# REGIONAL REVIEW NOTIFICATION

**ARC REVIEW CODE:** R2109281

**Name of Proposal:** Buice Lake South DRI #3403

TITLE  
DRI EXHIBIT

DATE	9/21/21
JOB NO.	20017
DWG FILE	20017pw2
DRAWN BY	TS
CHECKED	TS
SCALE	1"=100'
SHEET	P-1
1 OF 1

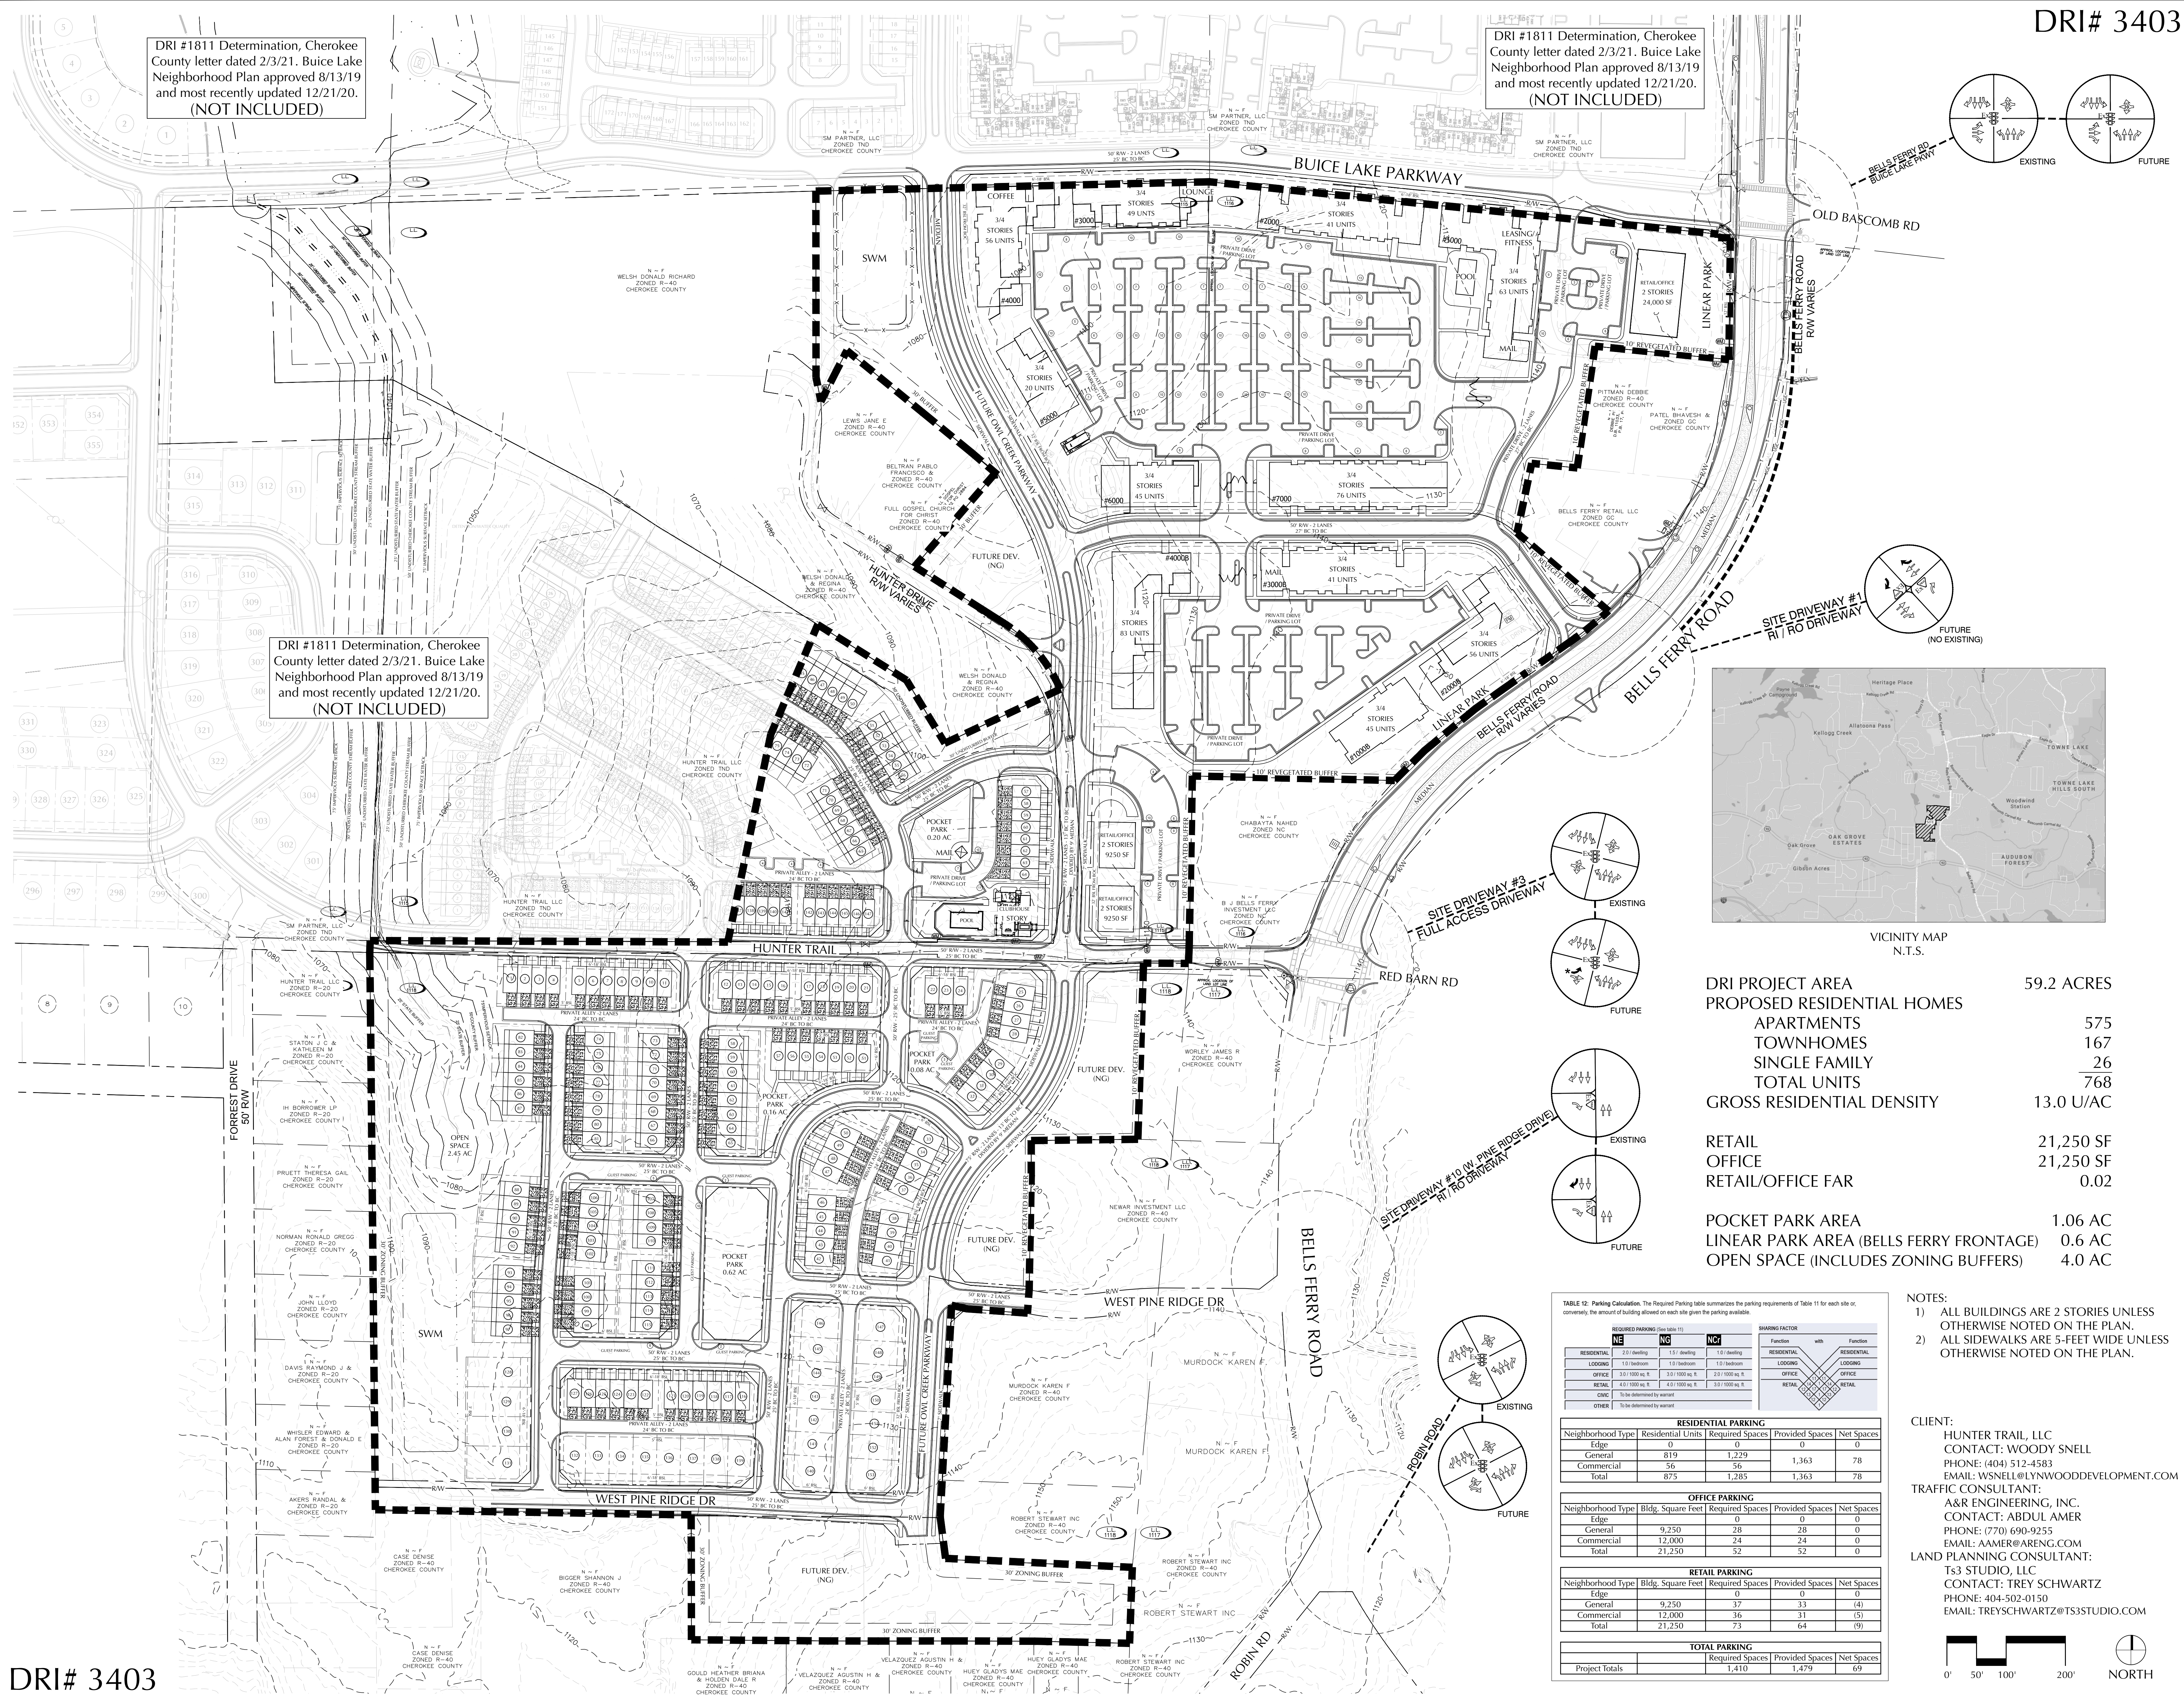
The potential use of the areas marked Future Dev NG note should be clarified and will need to follow the guidance and recommendations provided for the balance of the project.

Much of the site currently has an extensive tree canopy, including several large natural/undisturbed areas. While a number of pocket parks and stormwater management areas, and some open space, have been designated on the plan, it is unclear if any of them will incorporate existing tree canopy or natural vegetation. The project would be substantially enhanced by the retention of some of the extensive existing tree canopy and natural vegetation. Open space areas with tree canopy can become a significant community amenity if connected by adjacent sidewalks to the larger sidewalk network. These areas can also retain some of the site's existing carbon storage/sequestration capacity and resulting positive effects on local air quality.

ARC Natural Resources staff comments on water resources are attached. They indicate that no proposed impervious surfaces are shown intruding into State or County stream buffers. However, some of the project's townhomes appear to be close to the edge of the buffers. Any intrusion into the buffers may require variances.

Both the site plan and the USGS coverage for the project area show the headwaters of one blue line stream, Owl Creek, running along the western edge of the project property. The submitted site plan shows a stream with a short tributary on the eastern portion of the project property and a stream on the western side of the property. The site plan shows the 25-foot State Sediment and Erosion Control buffer as well as the Cherokee County Stream Buffer Ordinance's 50-foot stream buffer and 75-foot impervious setback. No impervious surfaces are shown intruding into any of the buffers. However, a few townhouses shown are close to the edge of the buffers. Any intrusion into the buffers may require variances. Any unmapped streams on the property may also be subject to the County stream buffer ordinance, and all waters of the state on the property are subject to the State 25-foot Sediment and Erosion Control buffer.

On the most southern portion of the parcel, the site plan illustrates a stub out on the future Owl Creek Parkway, which is just south of the West Pine Ridge Dr and the future Owl Creek Parkway intersection.

It is referenced that the project's frontage will be constructed with pedestrian facilities. In addition to the frontage, sidewalks are proposed along the future Owl Creek Parkway which the site plan references future development along the road.
